STAFF REPORT

SUBJECT: MCU-2021-0008
Village Apartments

LOCATION: 2600 N. Eagle Rd., in the NW ¼ of Section 4, T.3N., R.1E. (Parcel #S1104233730)

I. PROJECT DESCRIPTION

B. Proposed Site Plan (dated: 8/27/2021)

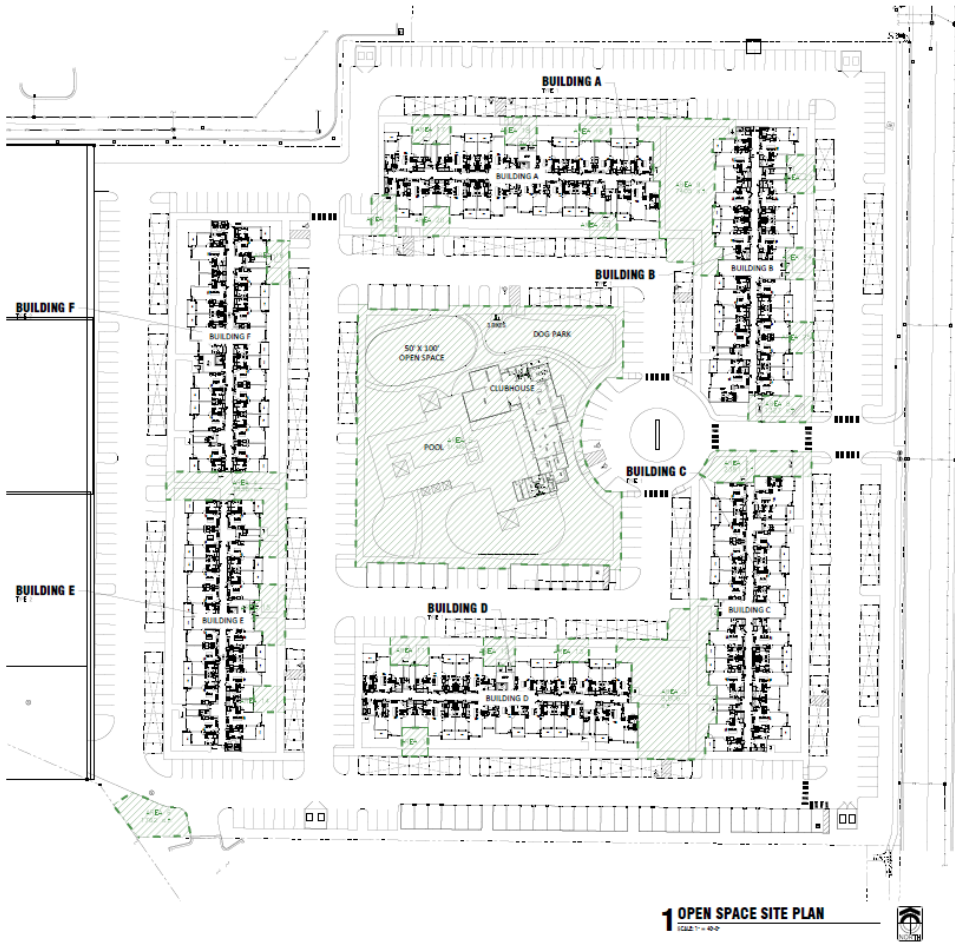
Access: One (1) access is proposed via N. Records Ave., a collector street, at the east boundary of the site. A driveway connection is proposed at the southwest corner of the site to the multi-family development (Regency at River Valley) to the south and two (2) driveway connections are proposed to the west to the future commercial development for interconnectivity. **Staff recommends cross-access/ingress-egress easements are recorded granting access to these properties.**

Staff is amenable to the request to remove the requirement for pedestrian and vehicular connectivity/cross-access to be provided to the residential development to the north as there is a sidewalk along Records Ave. that will provide pedestrian connectivity and UDC 11-3A-3A doesn't require vehicular cross-access/ingress-egress easements to be provided between residential properties.

6. A cross-access/ingress-egress easement shall be granted to the properties to the west (Parcel #S1104233650) and to the south (Parcel #R0748300210) in the locations where driveways are depicted on the site plan; a recorded copy of these easements shall be submitted with the Certificate of Zoning Compliance application for this development.

C. Open Space Exhibit (dated: 10/15/2021)

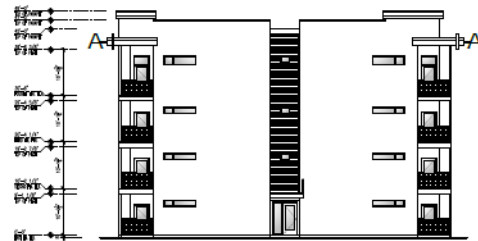
Common Open Space: Based on the square footage of the living area of the proposed dwelling units [320 between 500-1,200 square feet (s.f.); and 16 over 1,200 square feet], a minimum of 85,600 s.f. (or 1.97 acres) of common open space that meets the standards in UDC [11-4-3-27C](#) is required. A total of 88,591 s.f. (or 2.03 acres) is proposed, which is 2,991 s.f. (0.07 of an acre) more than the minimum required in accord with UDC standards. The site is also within close proximity to Kleiner Park, a 60-acre public park, that is 600'+/- to the southeast of this property.
